Application Number: 2012-612 **Application Date:** 10/16/2012 12:00:00
CBL: 045-E-042 *Not under the lowest land CBL*
Project Name: West End Place
Address: 40-44 Pine St. & 183-189 Brackett St.
Project Description: Mixed Use; 39 Residential apartments; 2 ground floor retail suites *eParking*
Zoning: B-1 *G.M. Def*
Other Reviews Required: Historic Preservation
Review Type: Level III Site plan

West End Place – Pine & Brackett Streets
#2012-612 CBL: 45-E-39,40,41,42 & 50
B-1 & R-6 Zones
11/1/2012

Re: Response to Review Comments
West End Place Planning Board Review

West End Place Mechanical Equipment Noise Data:

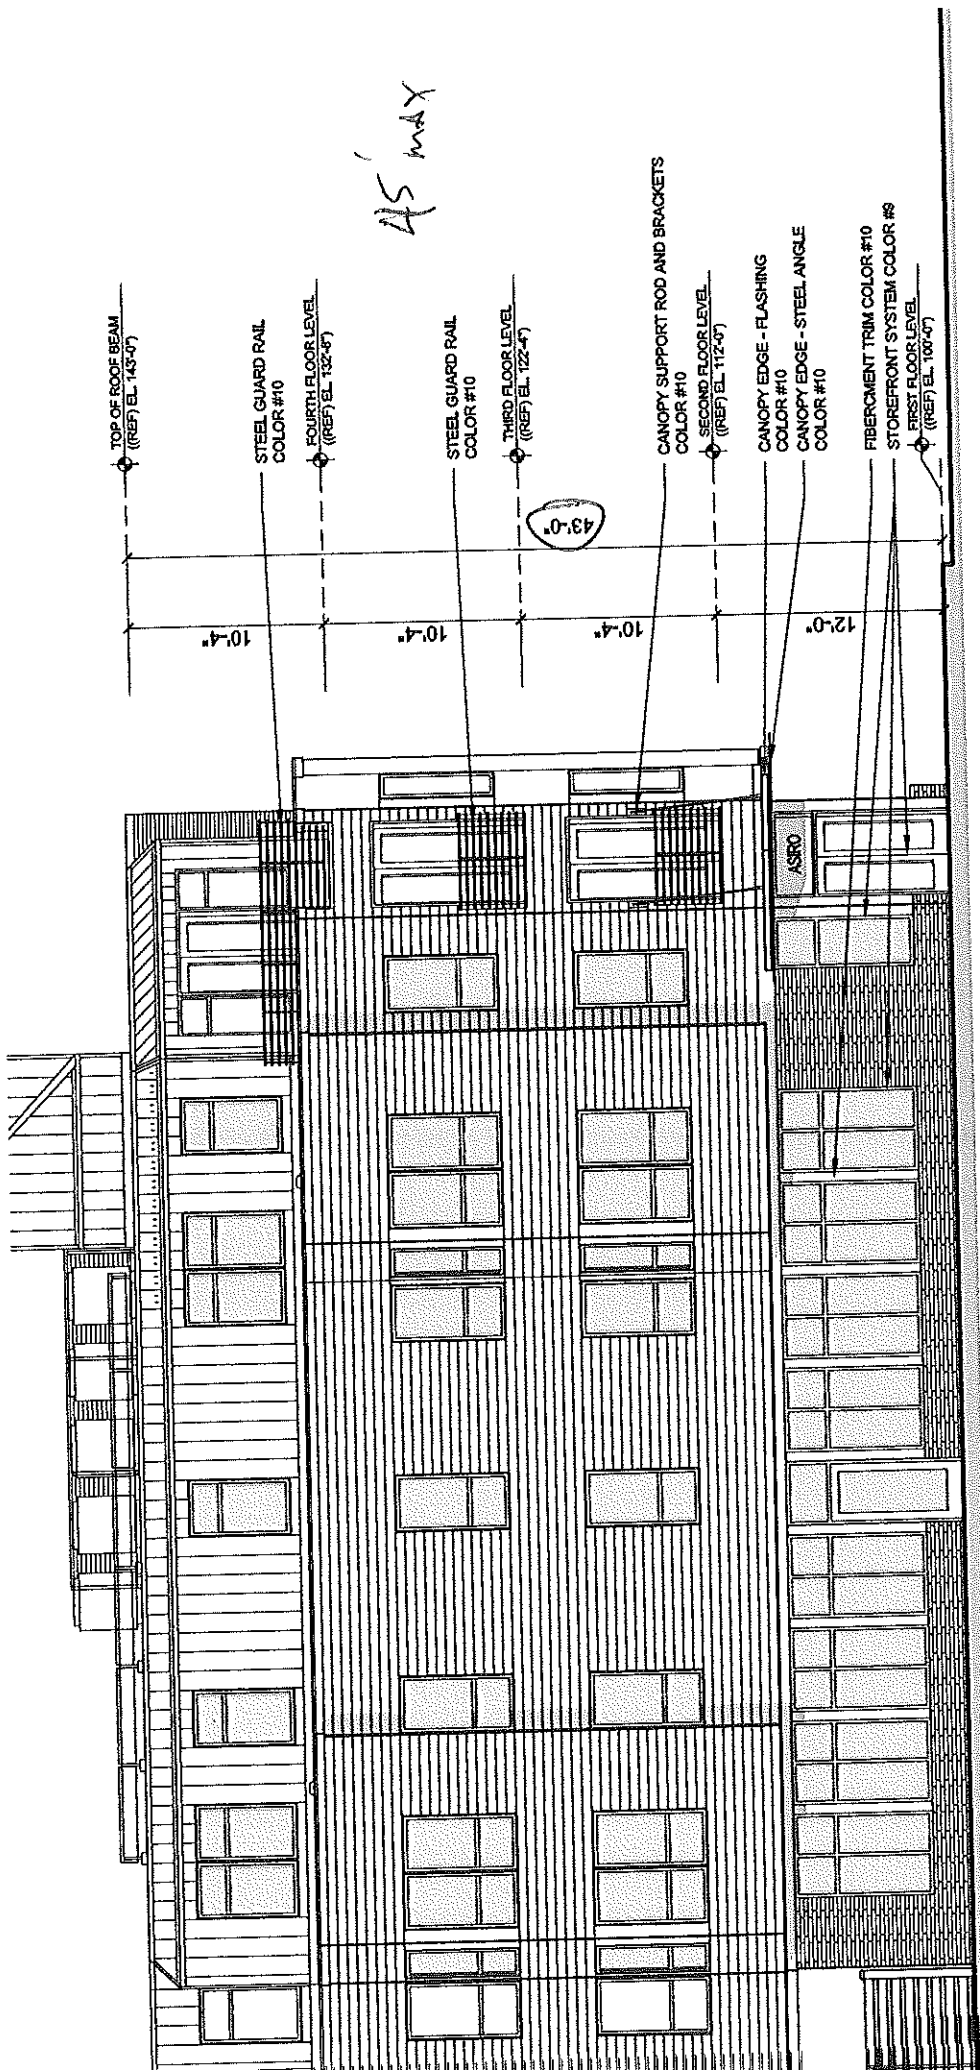
All HVAC units shall meet the maximum noise allowance as stated in the B-1 zone. At the time of HVAC permitting this office will require unit information on dBA emissions.

B-1 Zone 55 dBA max

Ranor Mechanical forwarded dBA information concerning equipment and their sound data. The bottom line is 52.6 dBAs at 3' from the unit or noise source. The B-1 Zone allows a maximum dBAs of 55. Therefore based on this information, the maximum noise level requirements of the B-1 zone are being met.

$$Lp(R2) = 52.6\text{dba}$$

WEST END PLACE

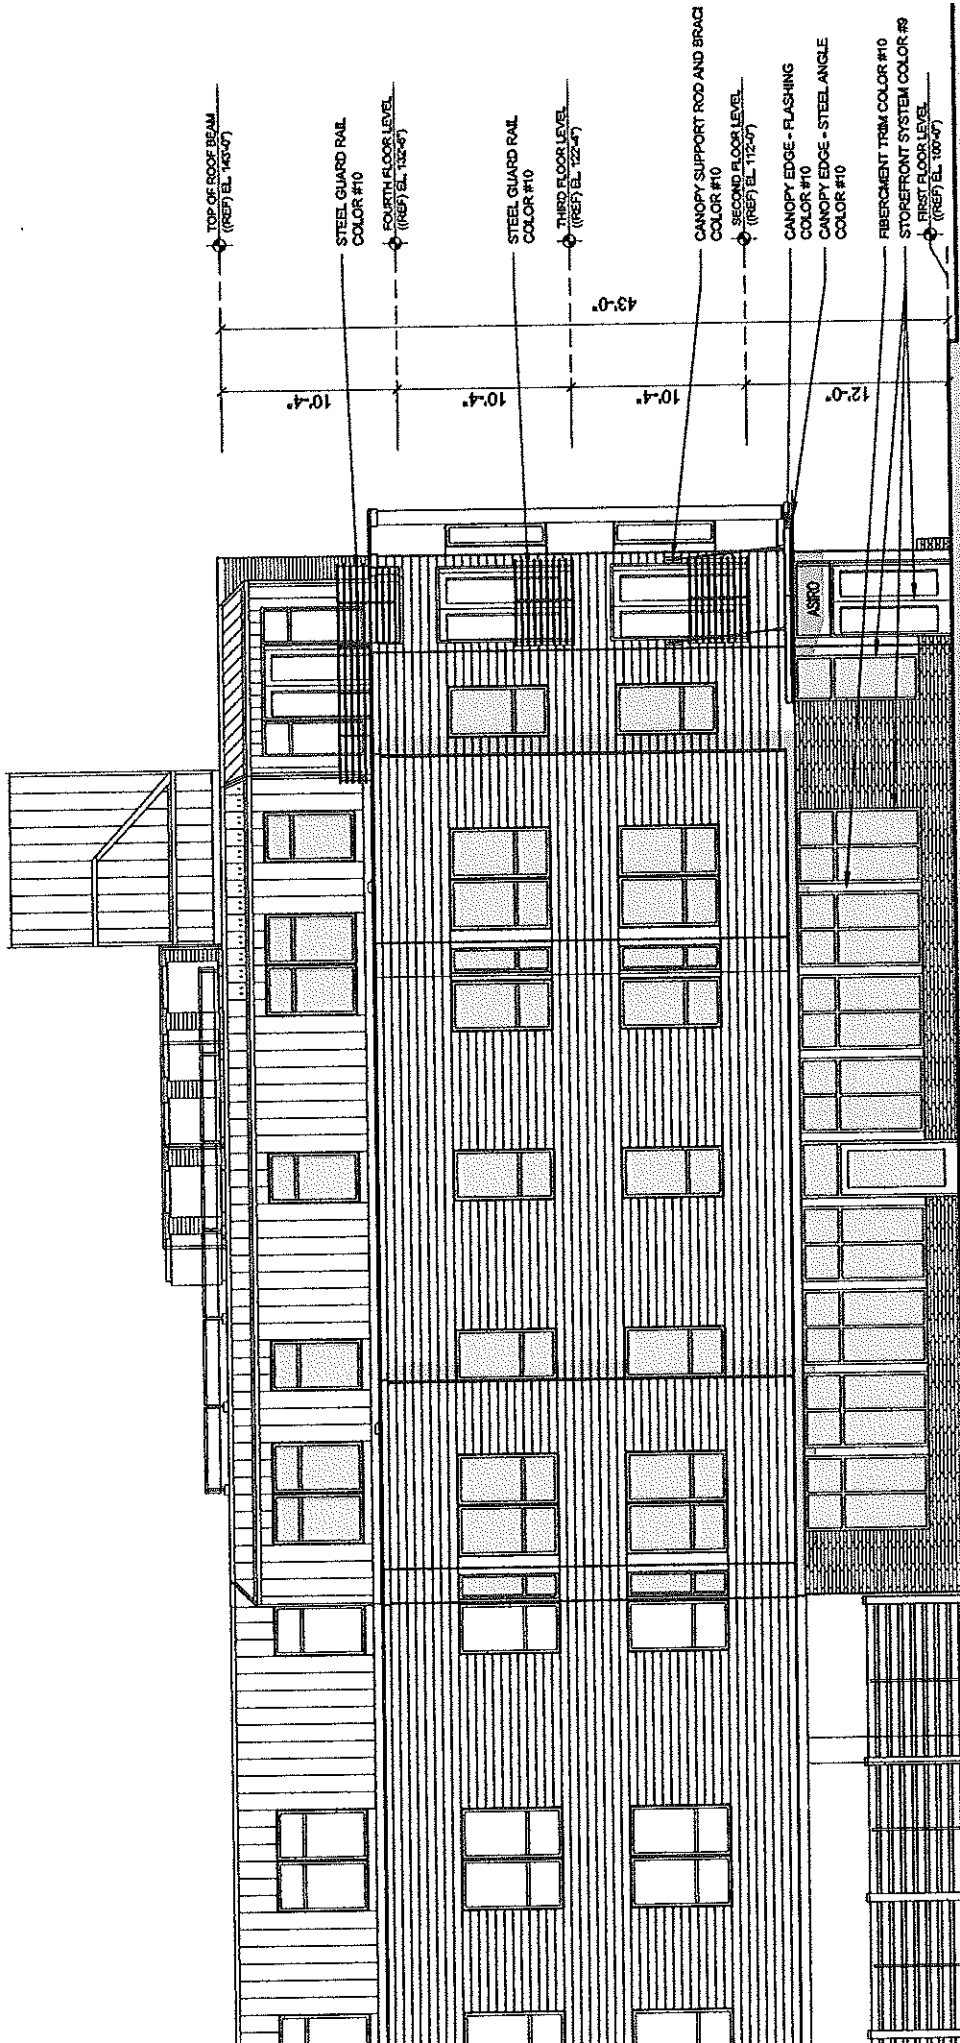
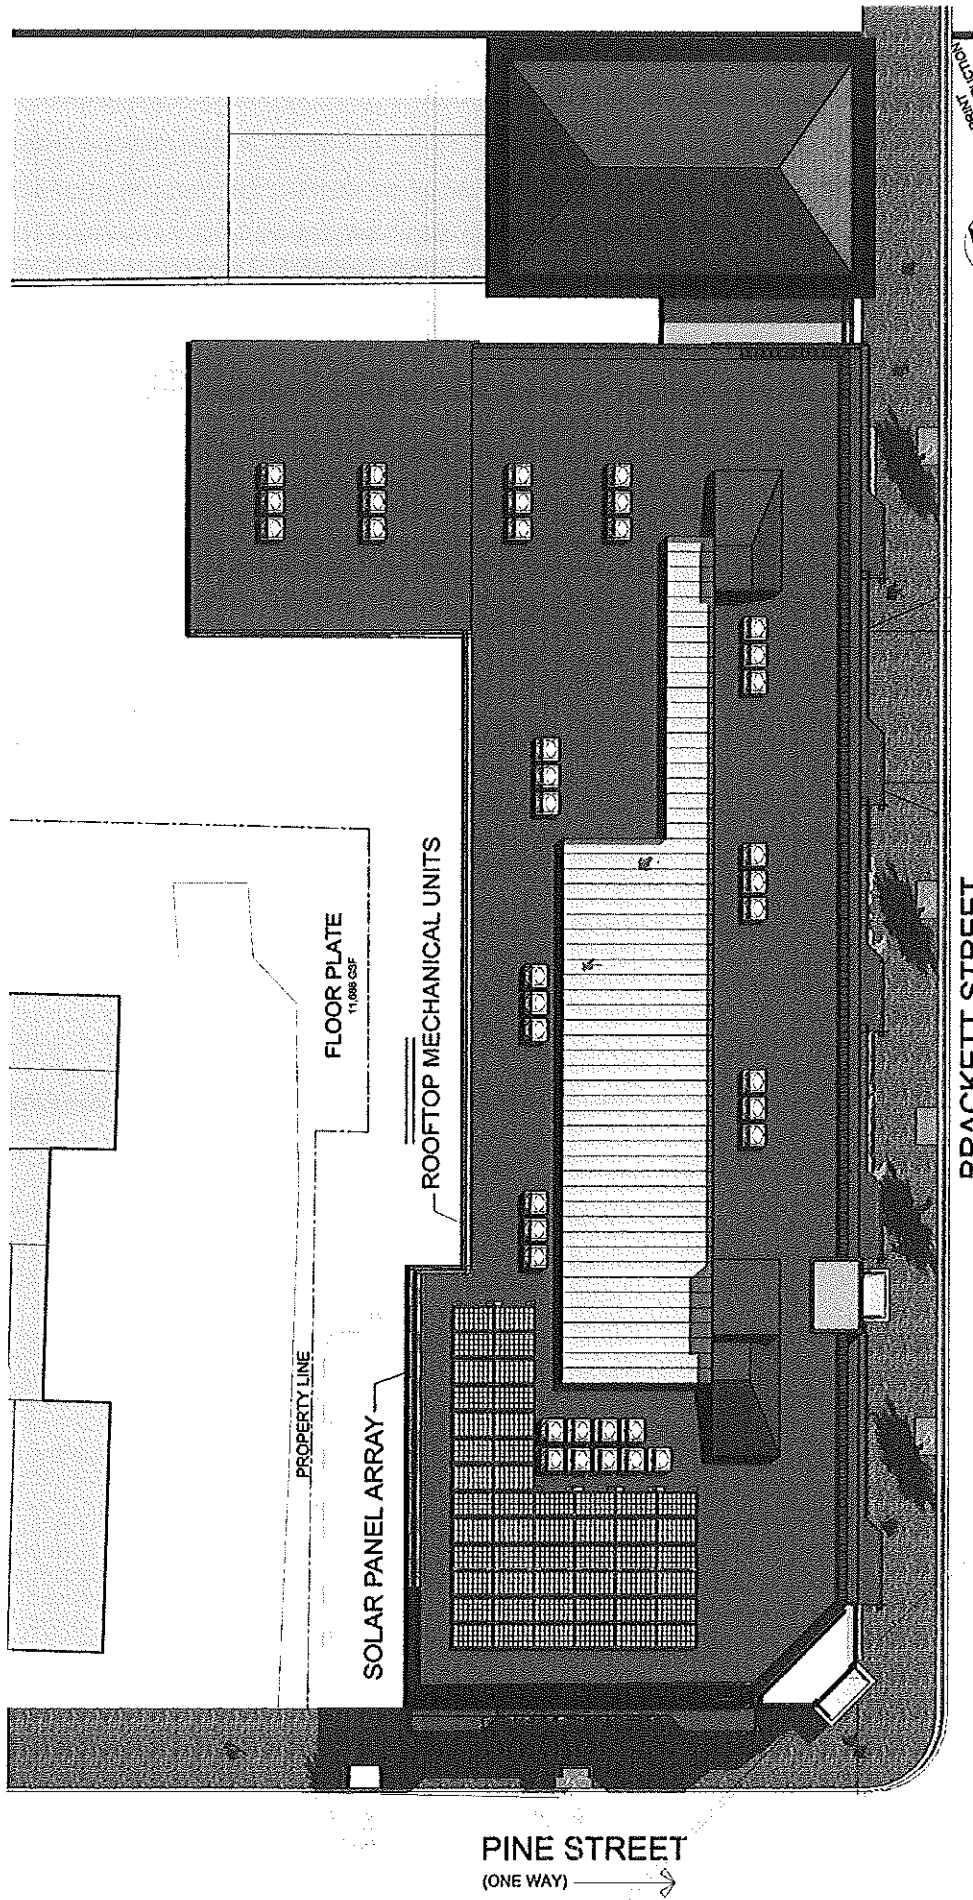
Height - 45' MAX - 4 stories shown - 43' shown - see 1/21/13 response letter NO AVERAGE grade received

The B-1 zone allows the retail uses and multi-family uses. The setbacks work if Pine Street is declared the “front” of the property. The initial information indicates that the maximum building height can be met. However, I would like more detail showing the average grades around the building and how that relates to the height. The maximum impervious surface ratio is being met.

Response: Pine Street is the Front of the Property. See the Grading Plan (Sheet C1-3) Indicating Spot Grades around the Building. The base floor elevation is 139.40', the building height of 43'-0" from top of roof beam of the proposed structure is measured from this elevation. The lowest grade at the face of building perimeter is 139.0'. At one location on the Northwest corner of the building, grades increase in all directions around the perimeter. The average grade will be higher than or equal to 139.40' and the building height of 43'-0" to top of roof beam from 139.40' will be below the 45' maximum for the Zone.

OK
on height
